**LOCAL HISTORIC DISTRICT:** Wesley Heights

**PROPERTY ADDRESS:** 612 South Summit Avenue

**SUMMARY OF REQUEST:** New Construction

## **Staff Analysis**

PROPOSED NEW STREET ELEVATION HEIGHT

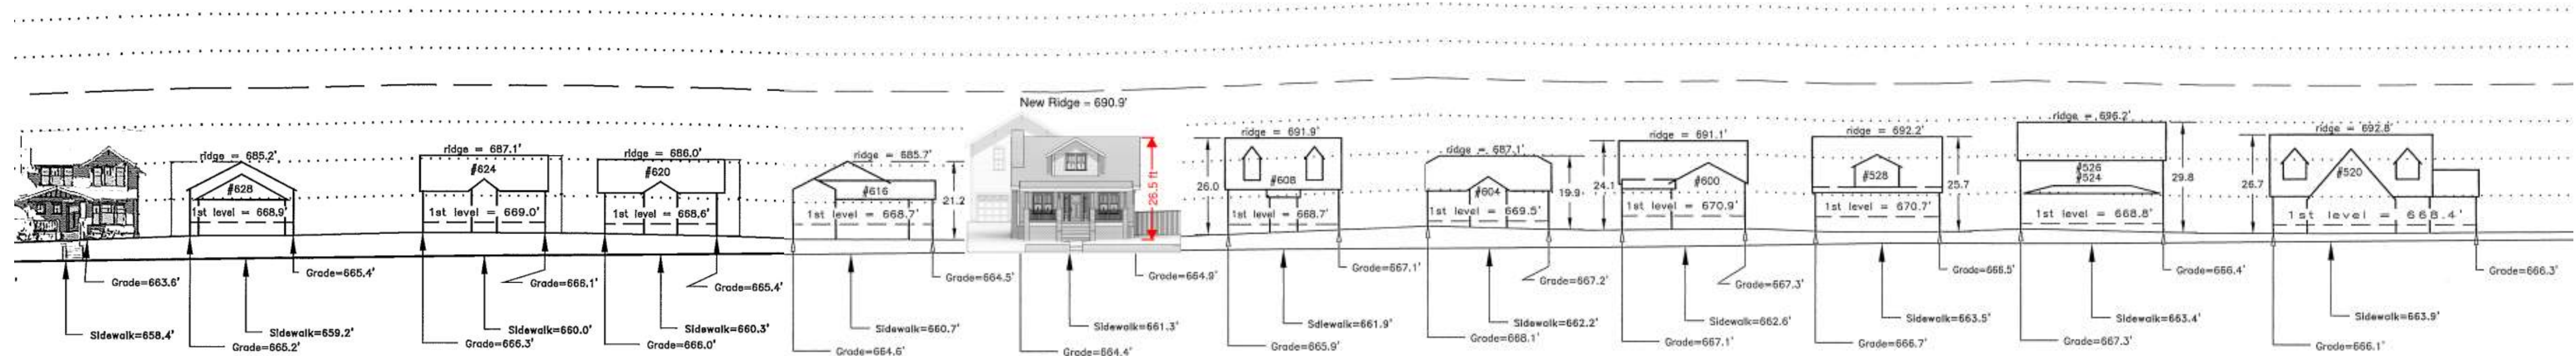
- *Additional notes and information on the drawings, i.e. roof pitch, materials, dimensions.*
- *Height, page 6.6, as relative to adjacent structures.*
- *Porches, 6.14, bracket details, beam-columns relationship, column proportions, front entry stairs and railing.*
- *Cornices and Trim, 6.11, trim and eave details.*
- *Massing, 6.5, rear roof pitch, coplanar dormer with the rear wall.*
- *Foundations, 6.9, the elevation of the foundation.*
- *Doors and Windows, 6.12 and 4.14, fenestration configuration on right elevation, information about the proposed windows.*

- Ridge height 26'-6 7/16"
- Roof pitches labeled
- Revised elevation drawings include re-designed rear dormer
- Beam-column detail provided

④ Bracket Detail  
1 1/2" = 1'-0"

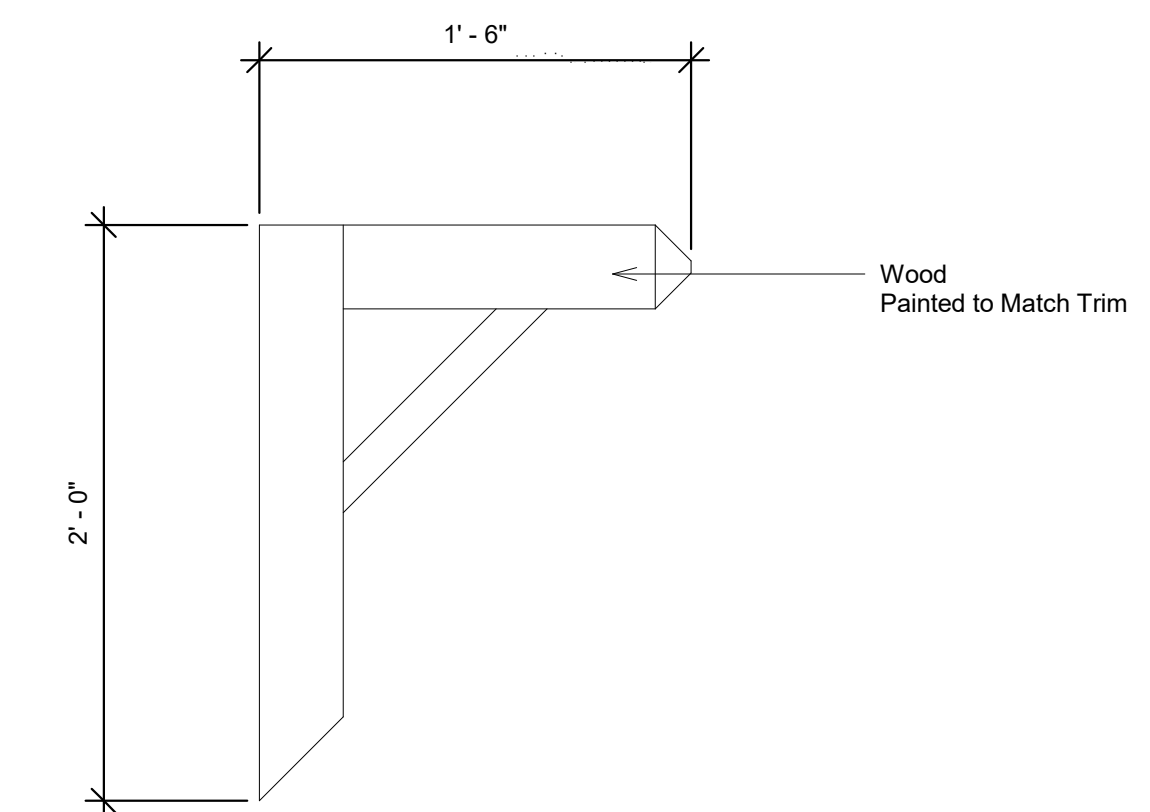
1. Height and foundation
2. Cornices, trim, and eave materials and dimensions need to be noted (ex: corner board trim dimensions, cedar siding thickness, soffit/fascia, window/door trim material)
  - a. Bracket detail – provide accurate drawing.
3. Confirm wood shakes will be individually applied and not pre-fabricated panels of shake.
4. Porches:
  - a. Front railing height/relationship between rail height and windows. Consider historic height rail with addition of a booster rail to meet code.
  - b. Missing a front porch handrail down front steps as required to meet code.
5. Doors and Windows:
  - a. Fenestration on right elevation.
  - b. Are proposed windows single-hung or double-hung?
  - c. Window muntin size.
  - d. Trim around rear entry door appears to be picture frame.
